SB-10056507-8532

GROUP ENG	MODEL 2015MY Sorento (XMa) Optima (QF)
	NUMBER 143 (REV 1, 09/18/2014)	DATE September 2014
TECHNICAL SERVICE BULLETIN		
SUBJECT: SERVICE ACTION: ENGINE CRANKSHAFT PULLEY AND BOLT REPLACEMENT (SA170)

OLD NEW

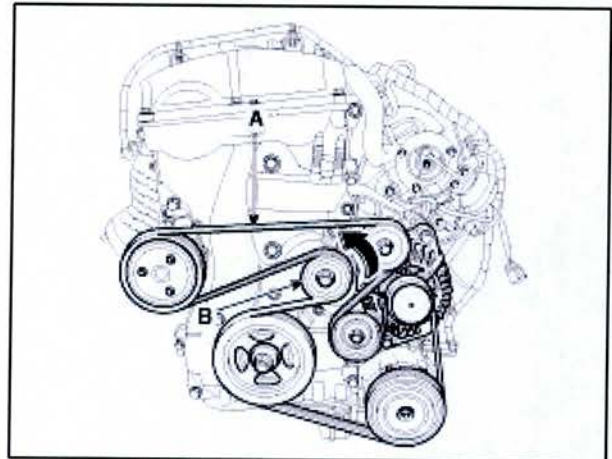
The replacement bolt and washer will be a one piece design. Do NOT use the two piece design.

- 6. Install the new crankshaft pulley and new crankshaft pulley bolt supplied in the kit and tighten to specification using a torque wrench. For detailed reinstallation procedures requiring the flywheel/flexplate to be held stationary, refer to:

Tightening Torque
122.8 ~ 130.1 lb-ft (166.6 ~ 176.4 Nm)
